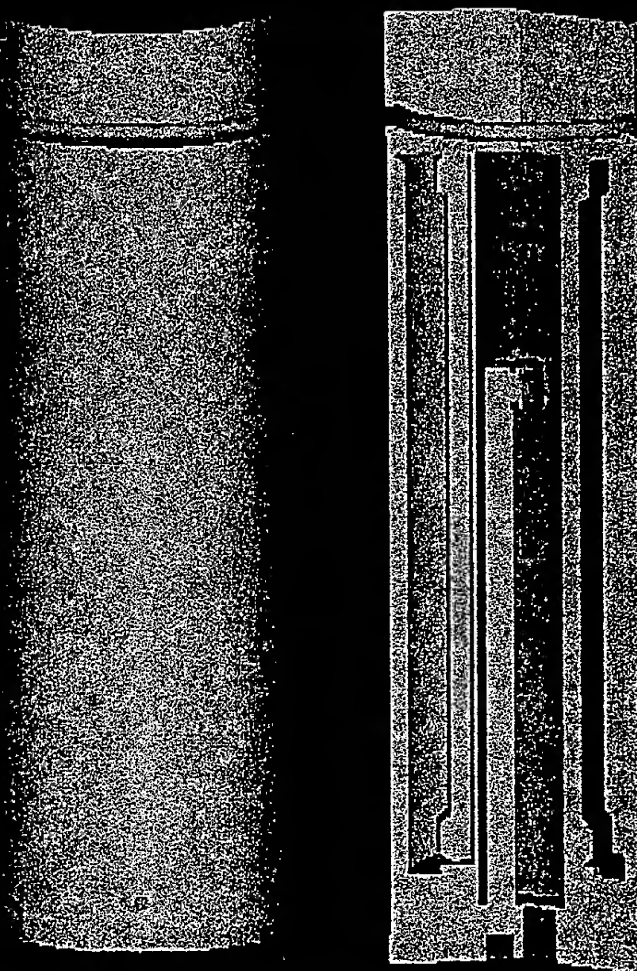
Possible new feature: Translucent polymer cap to inspect unit functioning.
Pressure regulator included?

1. Wasted space bet. filter & housing →
 - a. Provide insulative material to occupy space.
 - b. Use centrifugal action of oil flow in space to swing out particles.
 - c. Add extra filter element around mid core.
2. Oil pressure line lets contaminants drain back to engine.
 - a. Provide coiled tube w/ holes for oil exit & dispersion.
dispenses heat from incoming oil, providing less element melting.
3. If filter is snug against evaporation tube, and holes are at top of tube → filter life compromised and oil stagnation results. If oil drains back down through filter (holes at bot. of tube) → easy inspection of filter element.
